AECB Kent Group

Stonebridge Road Development adjacent to Kingsmead Playing Field

Introduction

Photo 3- External louvres to kitchens should not have insect mesh.

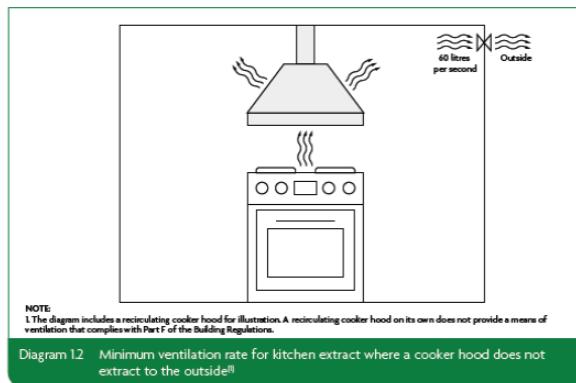
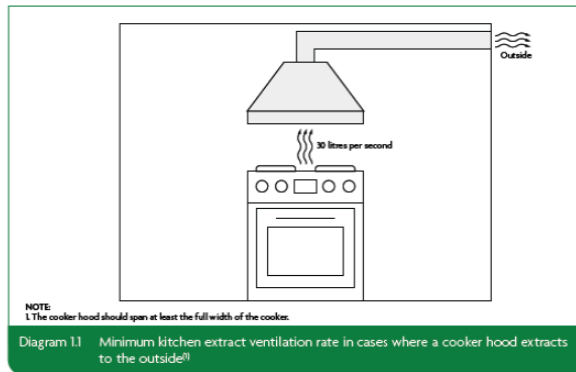
Bathroom fans have been used in the kitchen, contrary to Building Regulations, neither is there any grease filtering, the external grilles have insect screens, this results in blockages and diminished performance. See extract from building regulations below.
